Reference: AEC Contract AT(11-1)-1058
Task A
Consulting Services
Assignment DC-105A
PAR: 73-74 A

Subject: Preliminary Review of
Feedwater Sparger of Mill-
stone Unit 1 of Northeast
Utility Service Company (NUSCO)

FATIGUE LIFE OF FEEDWATER SPARGER
DESIGN NO. 3 , MILLSTONE UNIT 1

SHEET 4 OF 4

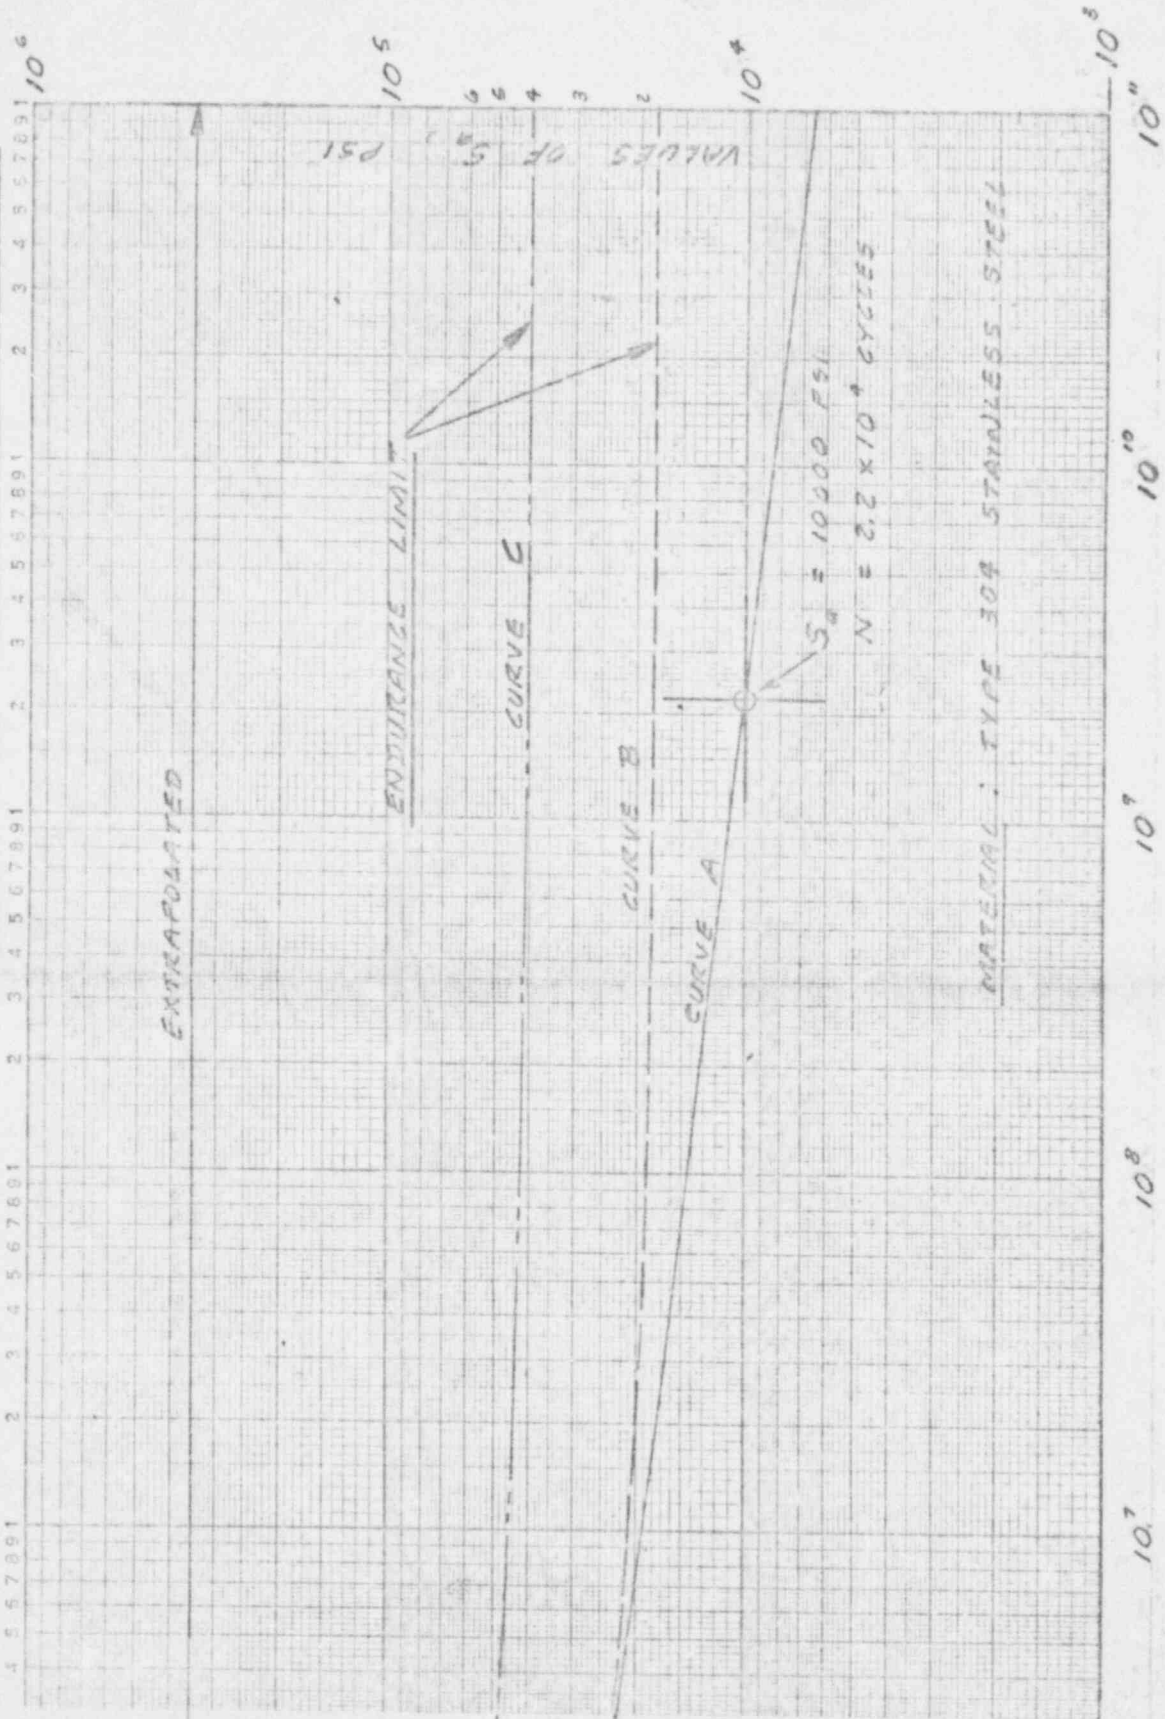
FROM EXTRAPOLATED CURVE "A" ON SHEET 4 ,

BECAUSE CURVE "A" HAS BEEN EXTRAPOLATED WITHOUT TAKING ENDURANCE LIMIT INTO ACCOUNT, RESULTS TABULATED ABOVE ARE VERY HARSH.

AS EXTRAPOLATED CURVE "B" SHOWS, INFINITE LIFE APPEARS TO BE JUSTIFIABLE AT $S_a = 18000 \text{ PSI}$.

FROM THE DESIGN FATIGUE CURVE ON SHEET 4,
 $N_T = 1000$ CYCLES AT $S_a = 110,000$ PSI ($= 92000 + 18000$).

NOTE THAT THIS PRELIMINARY STUDY OF FATIGUE LIFE WILL BE USEFUL IN EVALUATING GE/APED RESULTS WHEN THEY ARE REPORTED IN FINAL FORM. ALTHOUGH IT APPEARS THAT GE/APED HAS EXTRAPOLATED THE ASME SECTION III DESIGN FATIGUE CURVE CONSERVATIVELY, THEIR METHOD OF EXTRAPOLATION IS NOT KNOWN TO THE WRITER.
